## SERVICE BULLETIN

ENGINE - NO.4 BEARING COMPARTMENT - PROVIDE A NEW SOURCE FOR THE NO.4 BEARING -  
CATEGORY CODE 7 - MOD.ENG-72-0126

# V2500-ENG-72-0126

Location of the No.4 Bearing  
Fig.1

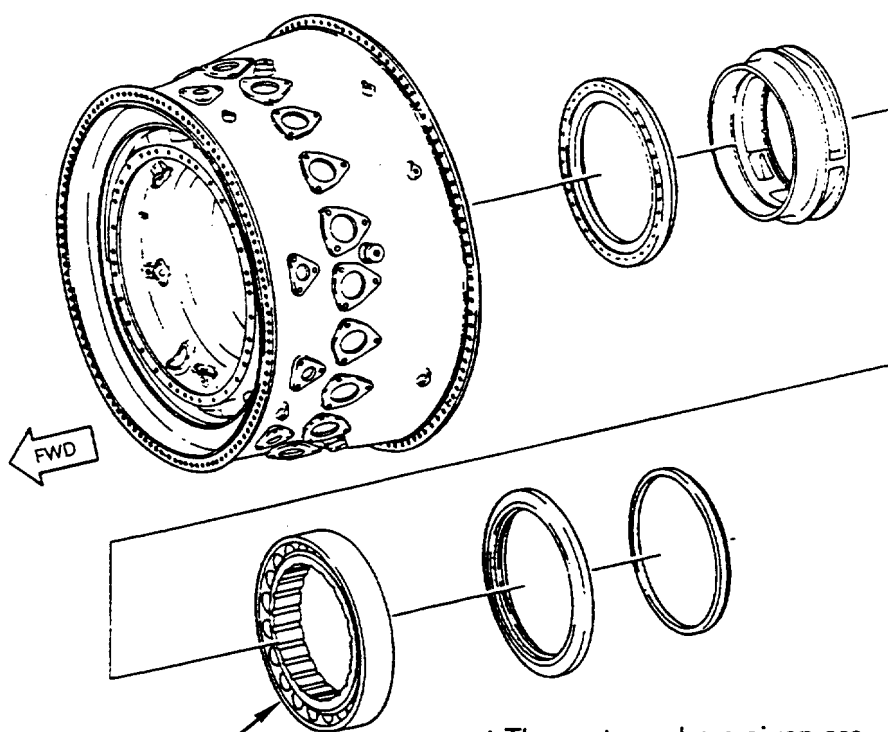
INSTALL THE  
2A0001 OR THE 2A0003  
No.4 ROLLER BEARING (1 off)\*

\*The part numbers given are  
details of the 2A0000  
bearing option

- (1) Install the 2A0001 or the 2A0003 No. 4 Roller Bearing (1 off). Use the approved procedure in Reference (2), Chapter/Section 72-00-43, Installation. See Figure 1.

. Family Tree - No.4 Bearing Catalog Sequence No. 72-43-13 Fig 01, Item 010  
Fig 2

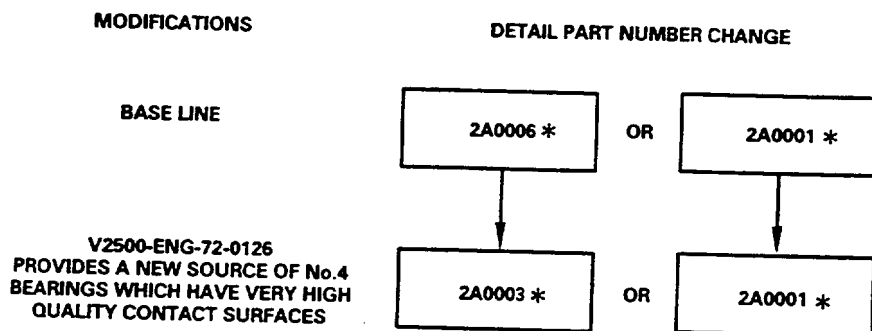
New Part No. (ATA No.)	Qty	Est'd Unit Price (\$)	Keyword	Old Part No. (IPC No.)	Instructions Disposition
2A0000 (72-43-13)	1	-	Bearing, Option	2A0000 (01-010)	(S1) (A)
2A0001 (72-43-13)	Ref.	-	Consisting of: .Bearing - Roller, No. 4	2A0001 (01-010)	(S1)
			or		
2A0003 (72-43-13)	Ref.		.Bearing - Roller No. 4	2A0006 (01-010)	(S1) (B)

- (S1) Old and New Parts coded (S1) are directly interchangeable.  
(A) New part is currently available  
(B) Old part will no longer be available.
